SUBJECT: ISSUANCE OF AMENDMENT NO. 44 TO FACILITY OPERATING LICENSE  
NO. NPF-41, PALO VERDE NUCLEAR GENERATING STATION, UNIT 1,  
(TAC NO. 71873)

The Amendment revises those portions of the Technical Specifications regarding Shutdown Margin, Control Element Assembly Insertion Limits, Azimuthal Power Tilt Allowance, and Departure from Nucleate Boiling Ratio Margin, in support of Cycle 3 operation for Palo Verde, Unit 1.

SUBJECT: ISSUANCE OF AMENDMENT NO.44 TO FACILITY OPERATING LICENSE  
NO. NPF-41, PALO VERDE NUCLEAR GENERATING STATION, UNIT 1,  
(TAC NO. 71873)

SAFETY EVALUATION BY THE OFFICE OF NUCLEAR REACTOR REGULATION  
RELATED TO AMENDMENT NO. 44 TO FACILITY OPERATING LICENSE NO. NPF-41,  
ARIZONA PUBLIC SERVICE COMPANY, ET AL.  
PALO VERDE NUCLEAR GENERATING STATION, UNIT 1  
DOCKET NO. STN 50-528

**FIGURE 3.1-1A**  
**SHUTDOWN MARGIN vs. COLD LEG TEMPERATURE**

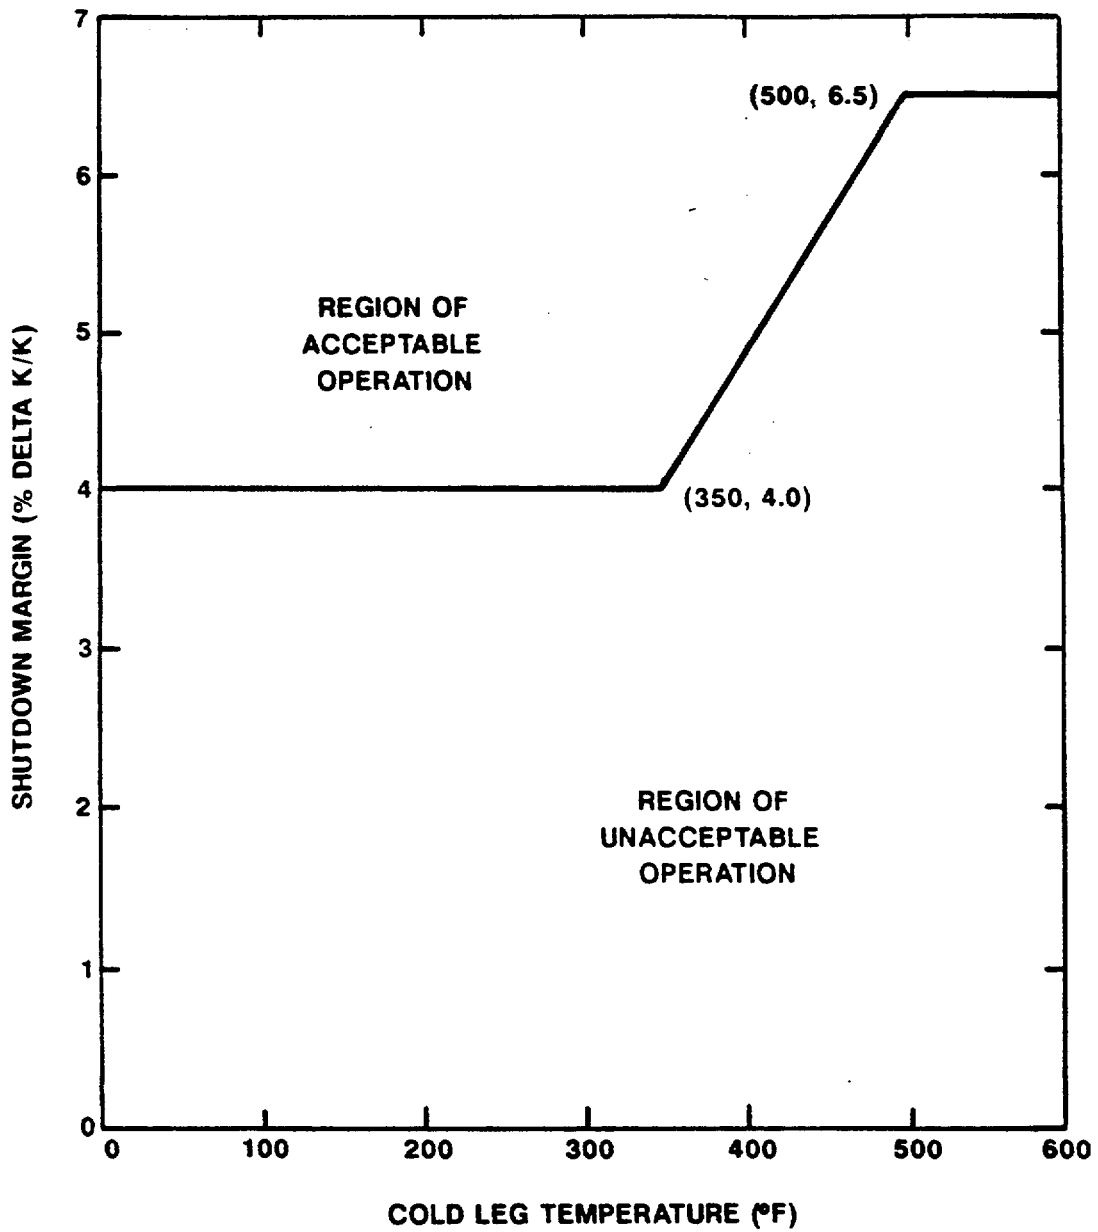
TS Figure 3.1-1A: The proposed change raises the required shutdown margin for cold and hot shutdown conditions from 3.5% delta-k/k to 4.0% delta-k/k to accommodate the requirements for inadvertent deboration. This change is necessary to satisfy regulatory requirements and thus, is acceptable.

FIGURE 3.1-3  
CEA INSERTION LIMITS vs. THERMAL POWER  
(COLSS IN SERVICE)

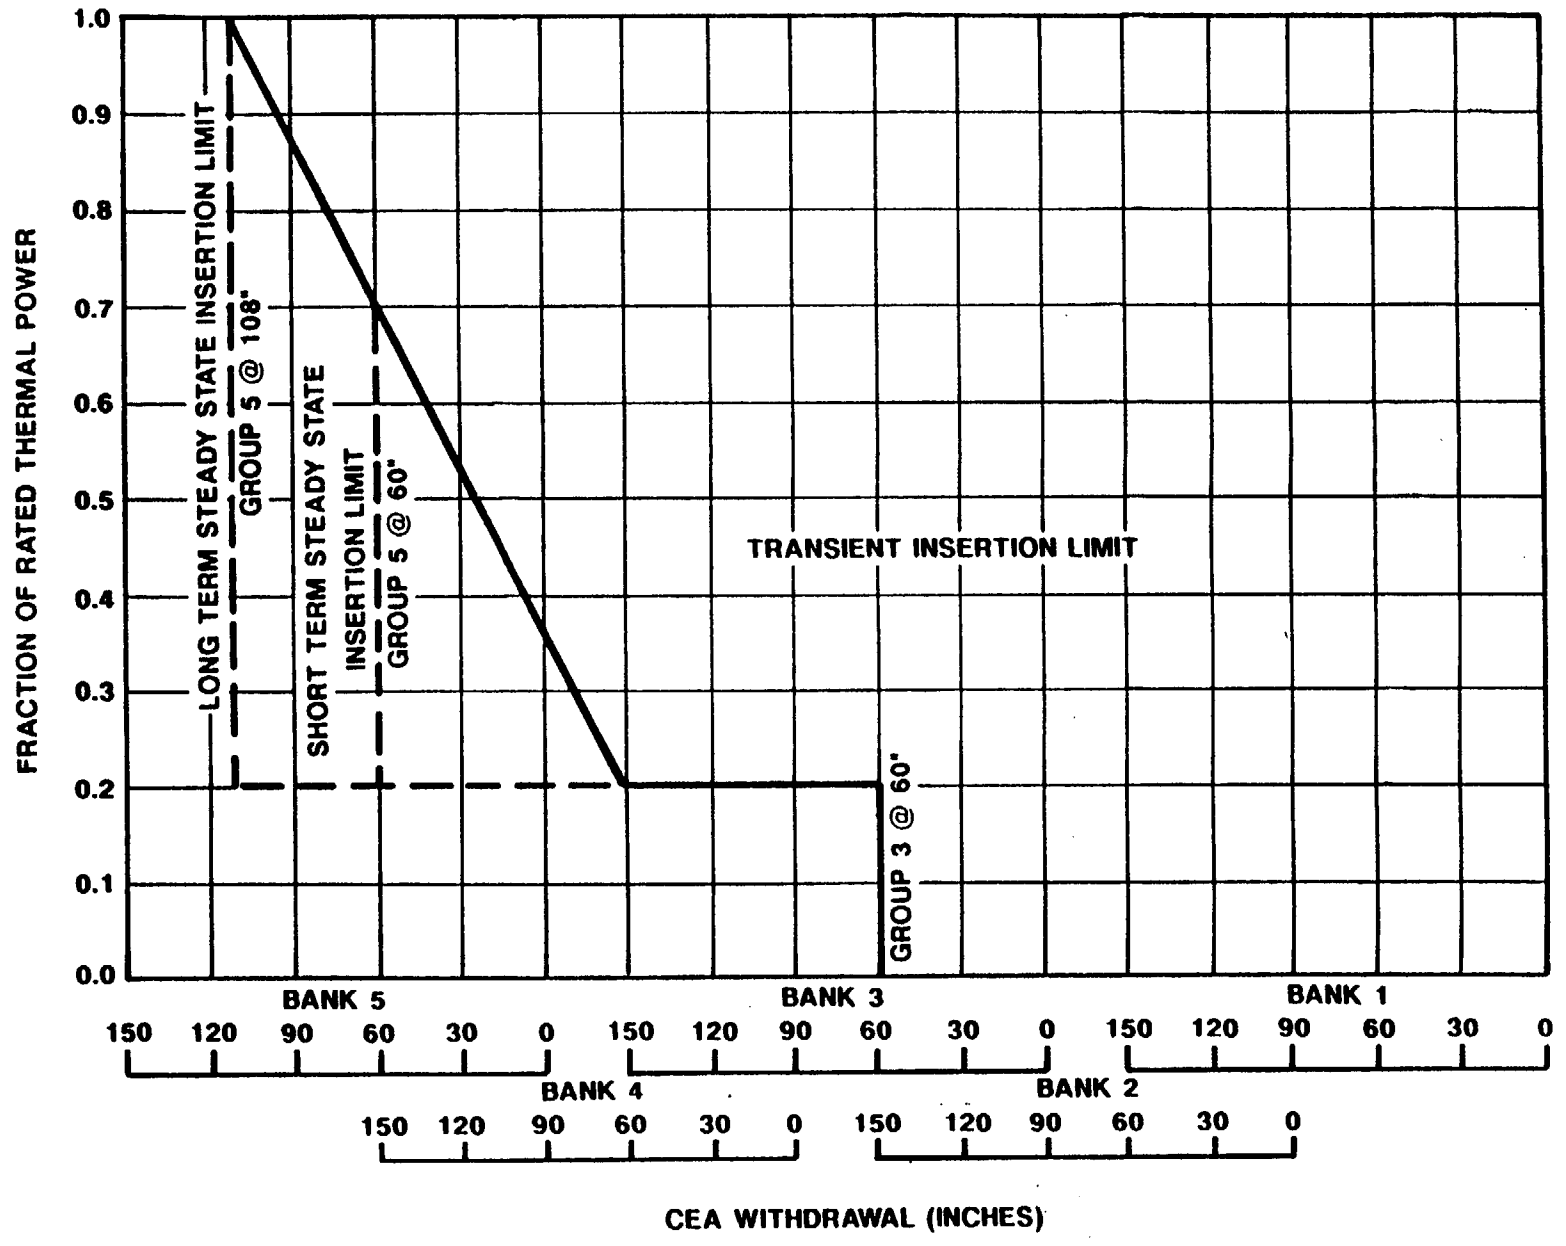
TS Figures 3.1-3 and 3.1-4: The proposed changes revise the curves of the transient insertion limit lines. These changes are required to make the Technical Specifications consistent with the Cycle 3 Safety analyses. Thus, the proposed changes are acceptable.

FIGURE 3.2-1A  
AZIMUTHAL POWER TILT LIMIT vs. THERMAL POWER  
(COLSS IN SERVICE)

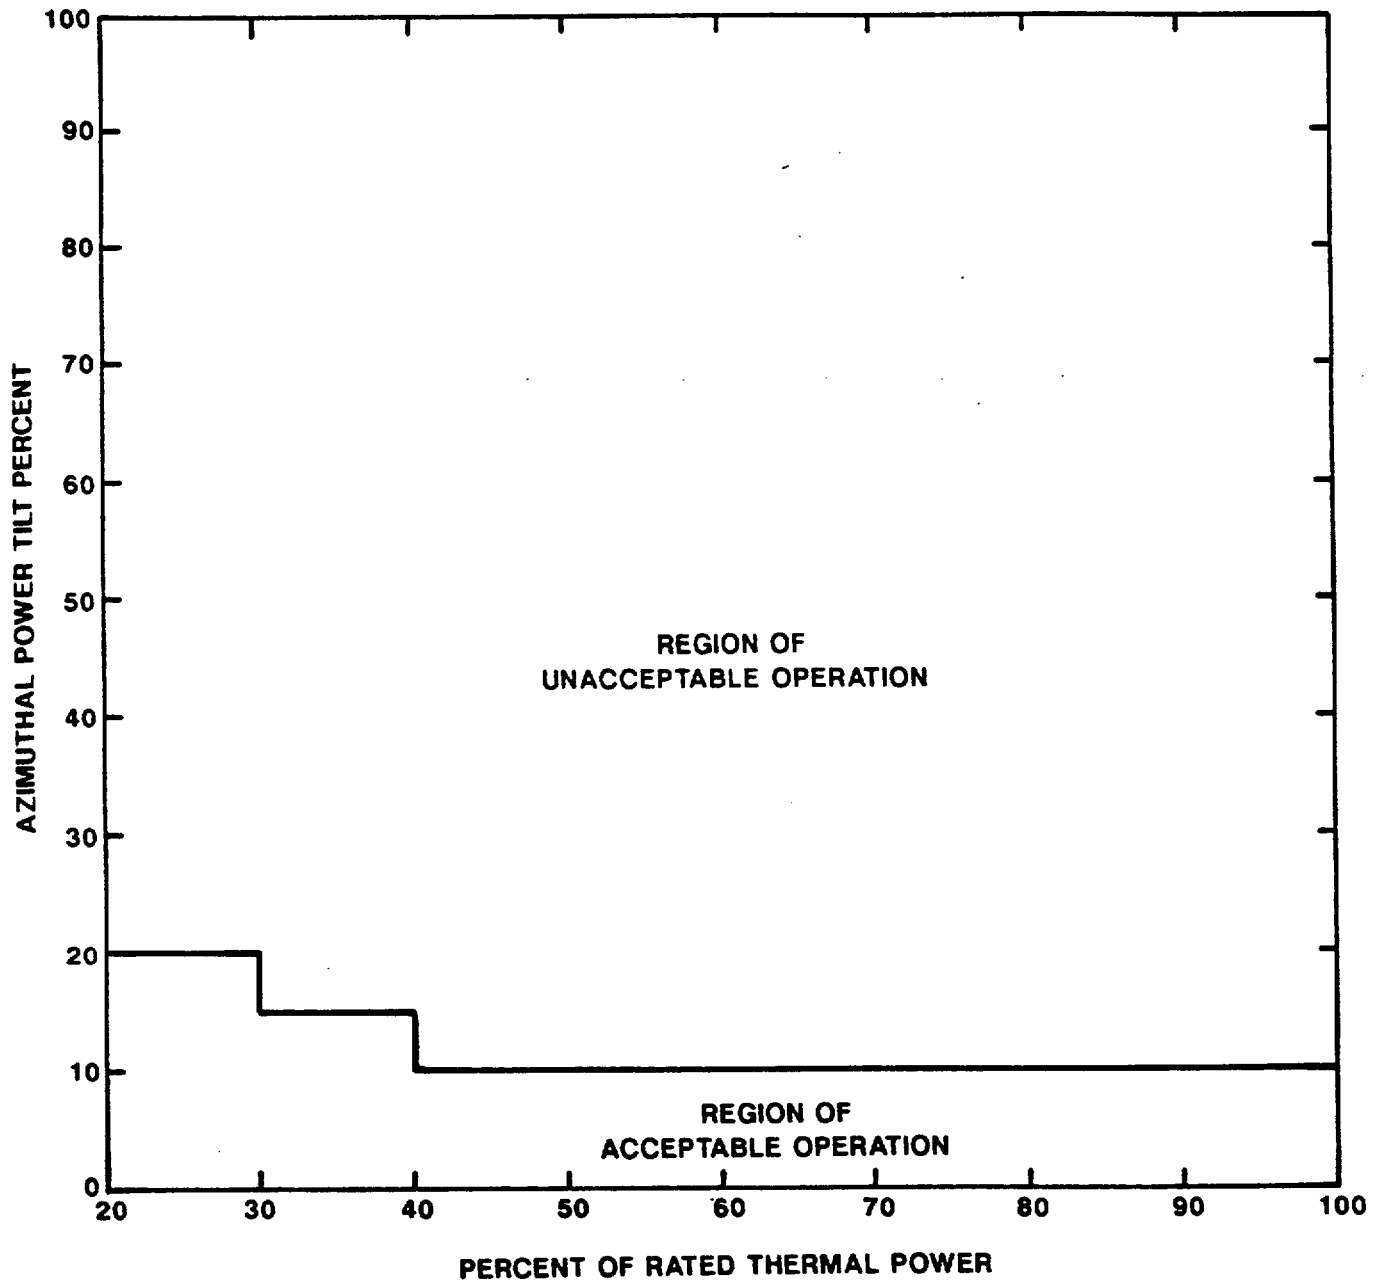
TS Figure 3.2-1A: The proposed change relaxes the azimuthal power tilt operating limits with the core operating limit supervisory system in operation, to avoid lengthy delays in increasing power. When the core operating limit supervisory system is in operation, reactor operation within the analysis limits is assured, therefore, the proposed amendment is acceptable.

**FIGURE 3.2-2**  
**DNBR MARGIN OPERATING LIMIT BASED ON CORE PROTECTION CALCULATORS**  
**(COLSS OUT OF SERVICE, CEAC'S OPERABLE)**

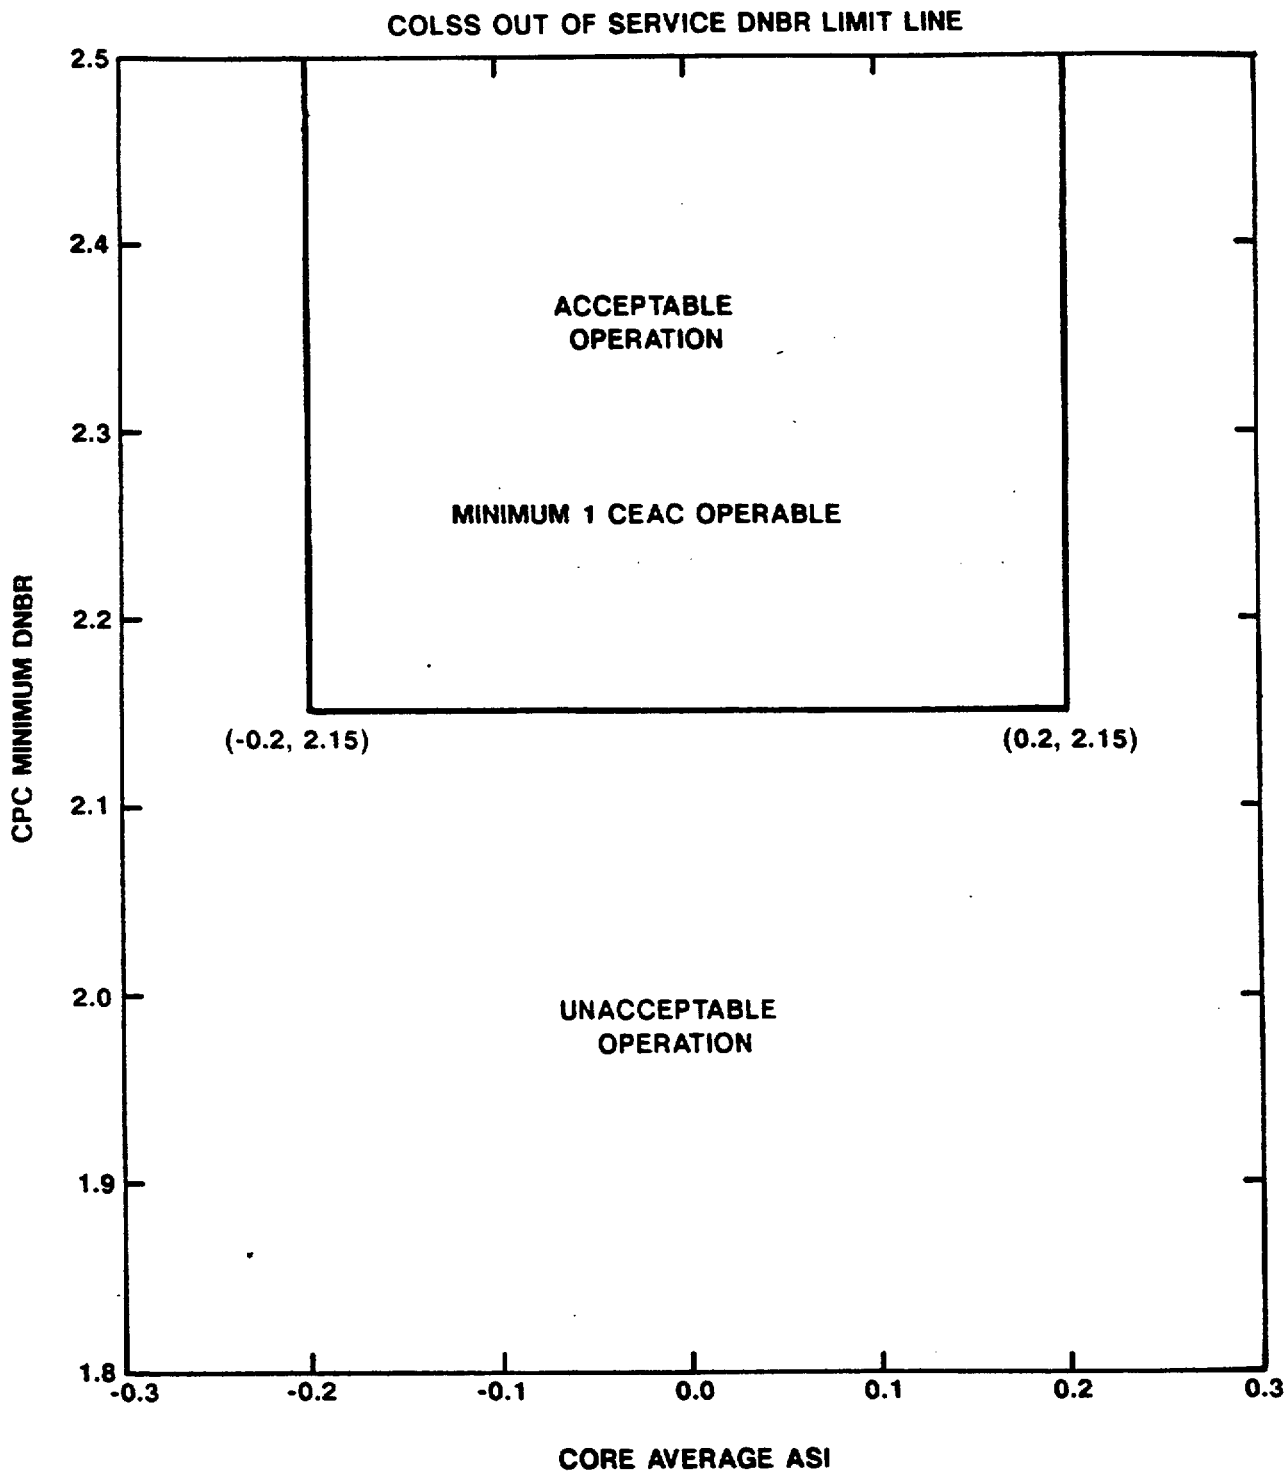
TS Figures 3.2-2 and 3.2-2A: The proposed changes revise the DNBR limit curves for combinations of CEACs inoperable with COLSS inoperable. These revisions are required to reflect cycle-specific parameter changes due to core loadings. The changes are required to ensure that the Technical Specifications are consistent with the safety analyses for Cycle 3, and thus, are acceptable.
